## URGENT FIELD SAFETY NOTICE

<b>Single Registration Number (SRN):</b>	BE-MF-000000909
--	-----------------

**Subject:** Incorrect handling of non-square Image pixel spacing in Enterprise Imaging XERO Viewer at initial load leads to incorrect placement of reference lines.

- Enterprise Imaging XERO Viewer (UDI-DI: 05400874000710)

Figure 1: Example of placement difference due to incorrect initialization in XERO Viewer

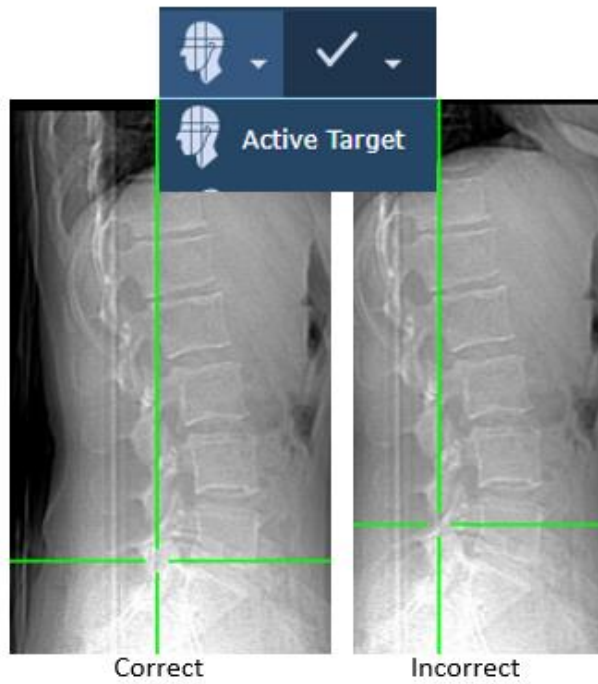
When an image has non-square pixel spacing, the reference/localizer line is incorrectly placed on the scout image in the XERO Viewer (offset from actual position). For example, when viewing a CT localizer radiograph, also known as a scanogram or scout image in the sagittal plane next to an axial series, the localizer/scout line or the active target localization tool may display the incorrect crosshair/line position on the non-coplanar/scout image with respect to the axial slice location.

This misplacement occurs only initially when viewing the anatomy in the non-coplanar image within XERO Viewer. When a user scrolls through other available scout/non-coplanar images in a series, or replaces the current image in the display area with another series and then returns to the first scout image viewed, the reference/localizer line or active target crosshair will subsequently be correctly placed.

Example of reference line placement difference in an affected study

Example of Active Target placement difference in an affected study

AGFA HealthCare will provide the software corrections for the affected versions. A patch is available for each of the following XERO Viewer version streams:

- Use the XERO Viewer Extended Tools component (Xtend), if enabled.
- Use the Enterprise Imaging Desktops viewer
- Scroll through other available scout/non-coplanar images in a series, or replace the current image in the display area with another series in order to correct any potentially misplaced scout line.
